CHRYSLER REAR DRIVE PREMATURE PLANETARY FAILURE

Figure 1

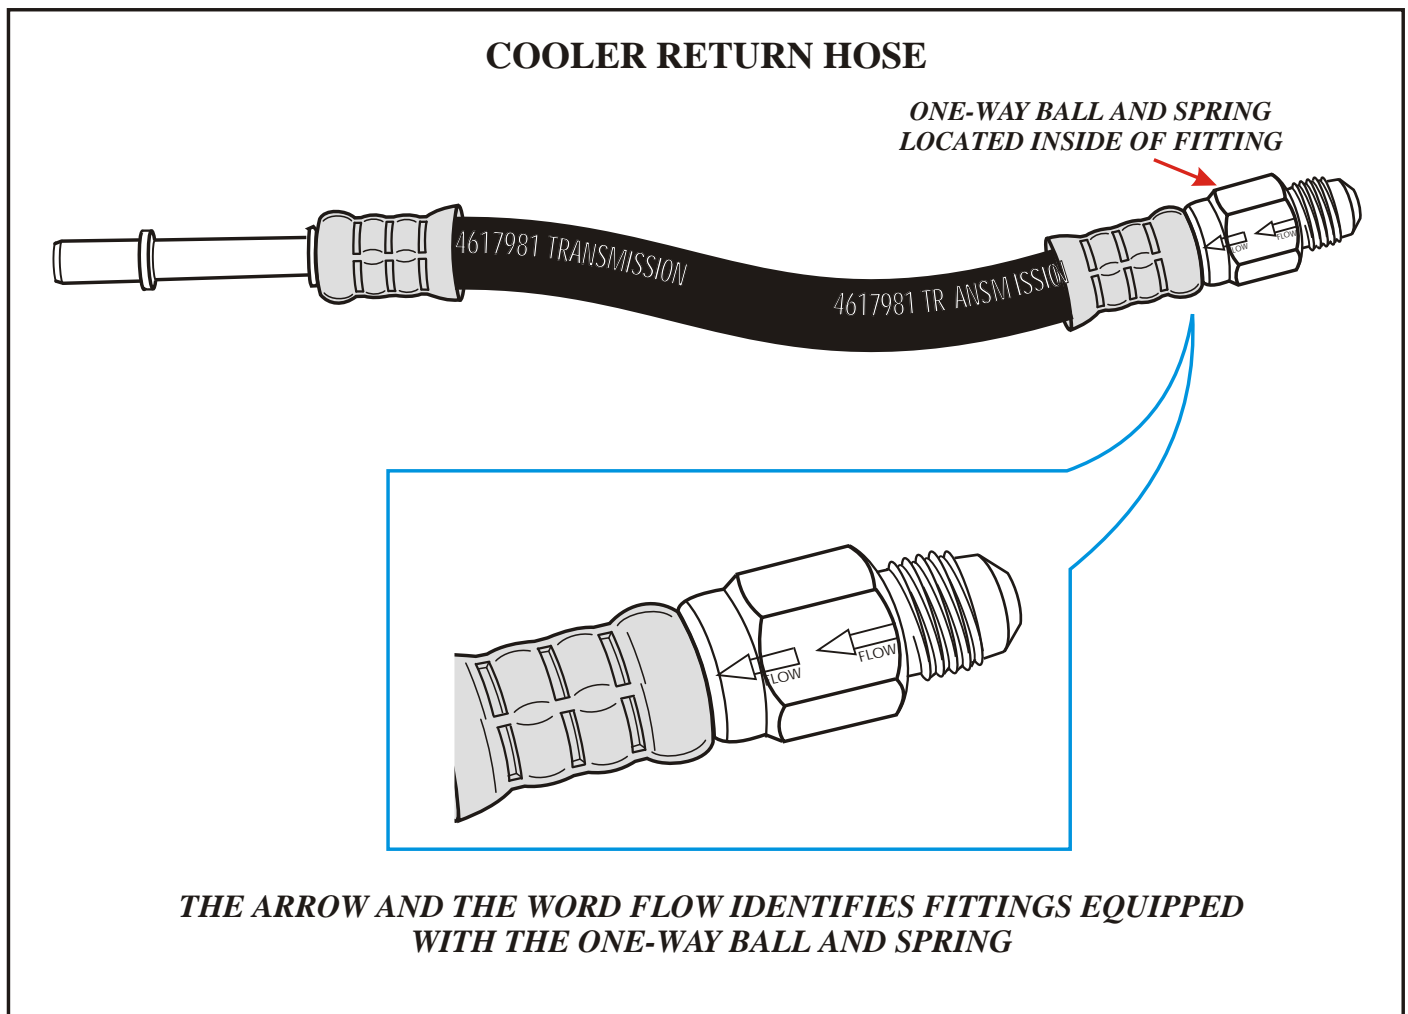
CAUSE: The cause may be, the one-way ball and spring located in the return cooler hose as shown in Figure 1, may be sticking and inhibiting cooler flow to the return cooler fitting which is the rear cooler fitting on the transmission.

CORRECTION: Locate the return hose which is near the radiator as shown in Figure 2. The threaded fitting will have an arrow and the word *flow* identifying the one-way ball and spring. Remove and discard the hose shown in Figure 1 and reconnect the existing lines with a suitable hose. After making the repair ensure that there is a minimum of 1 quart of fluid flow in 20 seconds when the rear cooler line is placed into a container and the transmission selector is in Neutral.
